# MISSOURI DEPARTMENT OF TRANSPORTATION

CONCRETE BLOCK TRUCK WASH DOOR ADDITIONS  
CENTRAL DISTRICT  
STEELVILLE, MISSOURI  
Route 8, 0.5 Miles East of Route 19  
Crawford County

## ADDITION AND CLARIFICATION

FLOOR PLAN  
Sheet 3 of 5

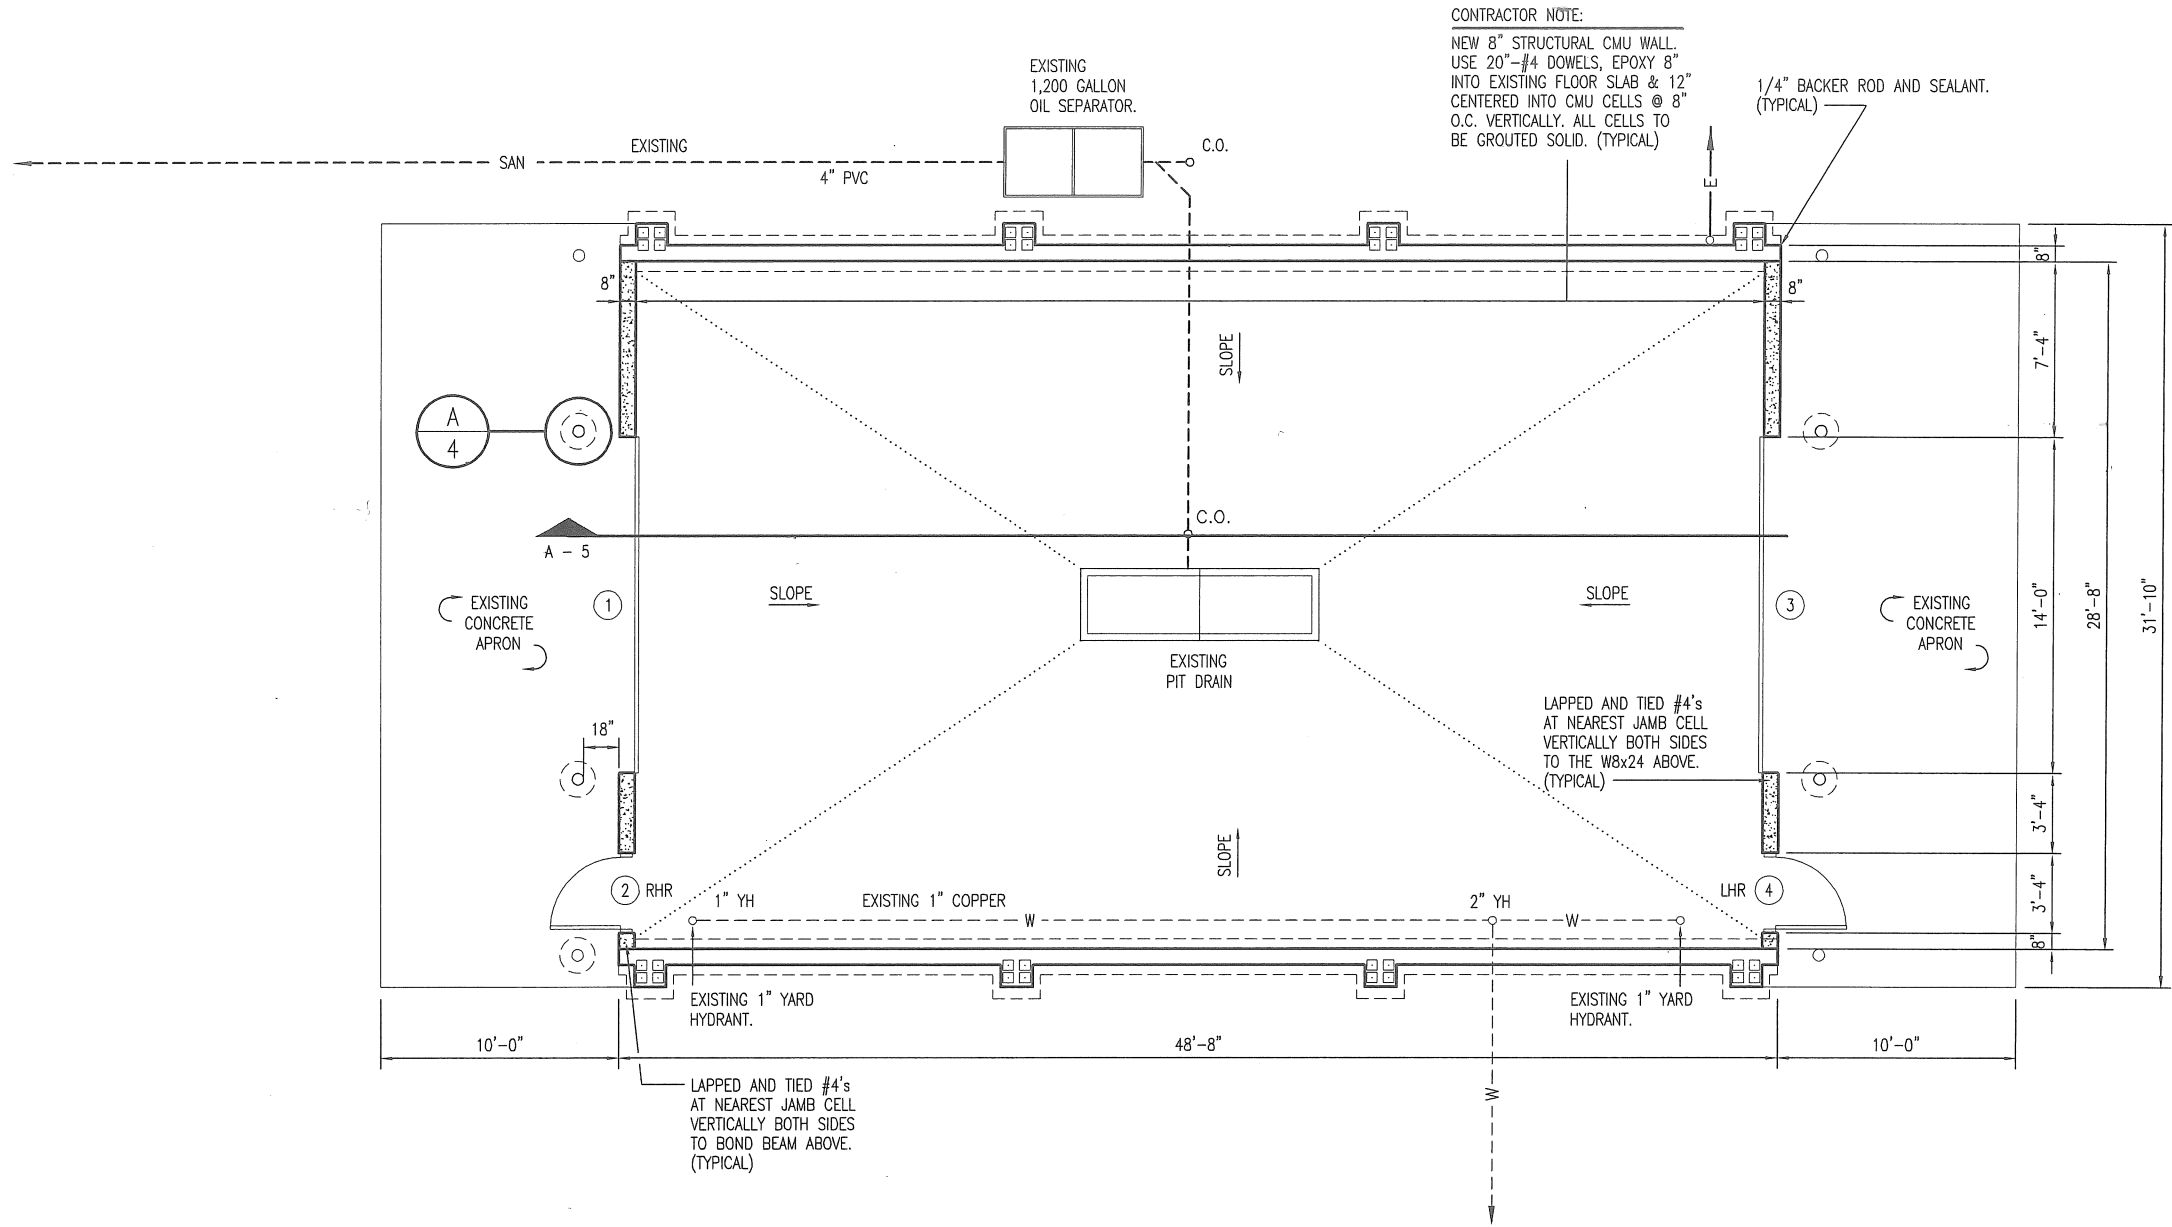
**Sheet 3** Add the following Contractor Note on Sheet 3 Floor Plan between pilasters:

**Contractor Note:** Remove existing 8" portion of structural CMU wall as required for installation of new exhaust fan. Trim/flash as required. Conduit, switch & conductors to fan by MoDOT.

BUILDING SECTION

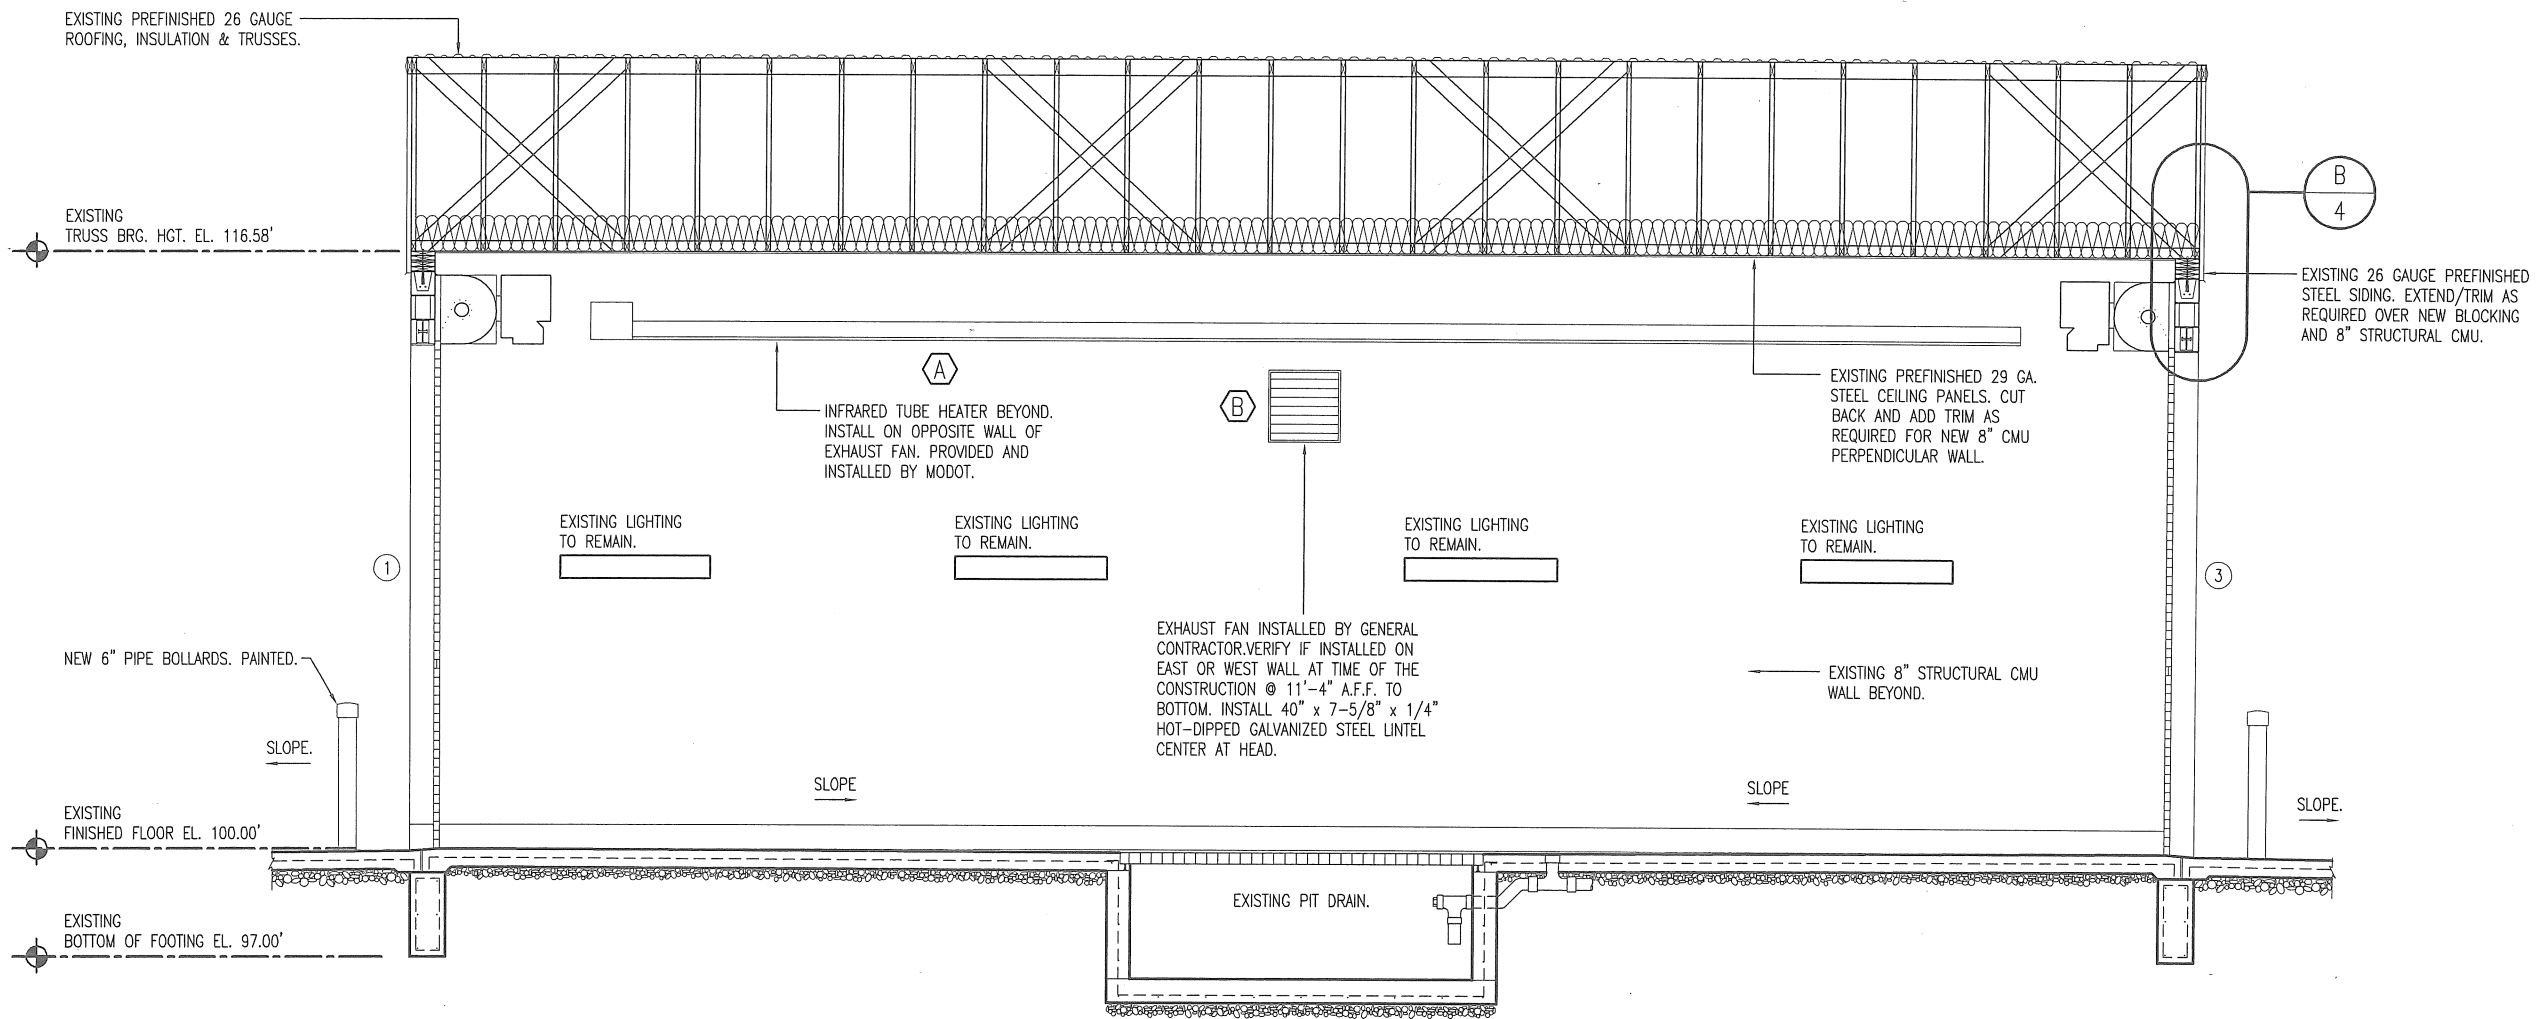
**Sheet 5** Indicates there is insulation above the ceiling liner panel. Clarification: Contractor shall install R36 blown in fiberglass insulation above existing ceiling and one, 24"x24" scuttle whole access with metal trim.
